D206-642-241
Job Sheet 192254

Part Name: Replacement Skidtube, High Gear with Standard Wearplates Fits LH or RH

DRAWING NO. D2650	TITLE 206/407 SKIDTUBE ASSEMBLIES	REV. F	DART AEROSPACE LTD ENGINEERING ORDER		D.E.O. NO. D2650-F-1	SHEET NO. SHEET 1 OF 1	SCALE NTS
DRAWN <i>JP</i>	CHECKED A.P.	MFG. APPR. <i>DA</i>	APPROVED <i>H</i>		DE APPR. <i>H</i>		
DATE 12.10.12	DATE 12.10.22	DATE 12.10.22	DATE 12.10.22		DATE 12.10.22

CHANGE C'BORED WELDED CROSSBOLT SPACERS TO SWAGED SPACERS

DETAIL B

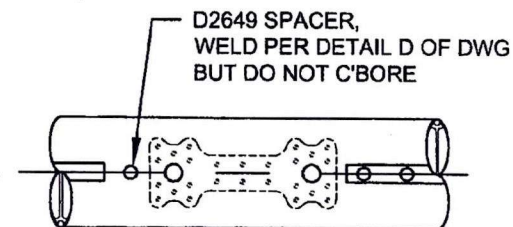
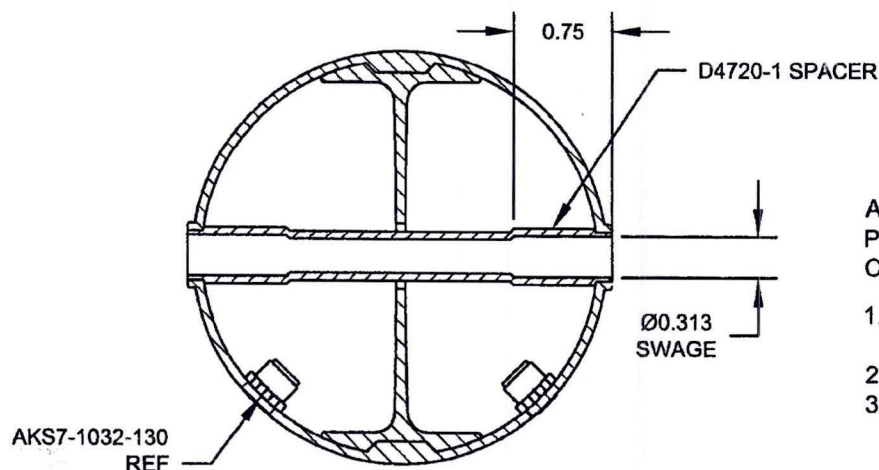
ADD DETAIL G BELOW, WHICH IS THE SAME SECTION VIEW AS DETAIL D OF DWG.
C'BORED HOLES ARE NOW SWAGED PER DETAIL G BELOW. FOR THE Ø0.375 HOLE THAT IS NOT C'BORED, WELD PER DETAIL D OF DWG (SEE AMENDED DETAIL B FOR REFERENCE).

1. INSERT D4720-1 SPACER, 16 PL (-1) OR 17 PL (-3)
OR 19 PL (-5) OR 23 PL (-7)
2. SWAGE TO Ø0.313 X 0.75 DP PER QSI 002
3. TRIM / GRIND FLUSH PER QSI 002
